November 9, 2004

RE: Submittal of Revised Administrative Organizational Chart for the Ohio State University Research Reactor (OSURR) Technical Specifications, License R-75, Docket 50-150

Figure 6.1: Administrative Organization

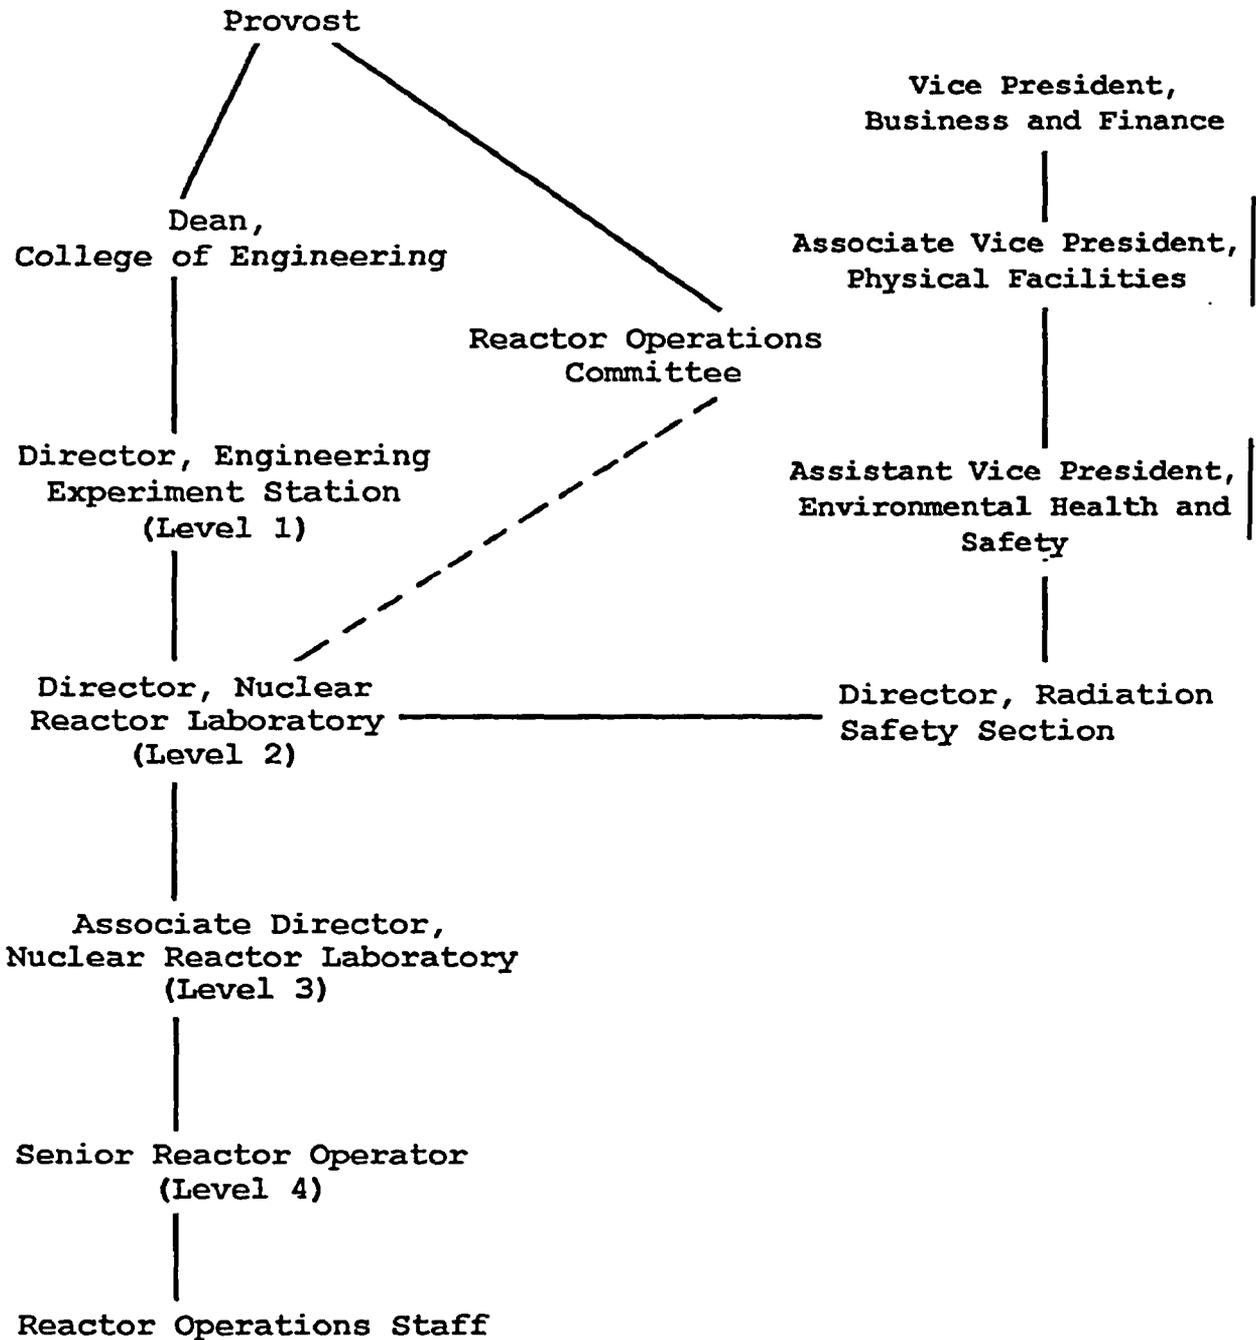
This letter is being submitted to document a proposed revision to Figure 6.1 (enclosed) of the OSURR Technical Specifications. This change was reviewed and approved by the Reactor Operations Committee as required in Technical Specification 6.2.4(3) at its March 2, 2004 meeting. It simply incorporates the Assistant and Associate VP positions that exist in the chain of command between the Director of the Radiation Safety Section and the VP of Business and Finance. It does not lessen the independence of the Radiation Safety Section from the OSU Nuclear Reactor Laboratory and thus does not reduce the effectiveness of the Technical Specifications. Questions on this change should be directed to Mr. Andrew Kauffman, Associate Director of the OSURR at 614-688-8220.
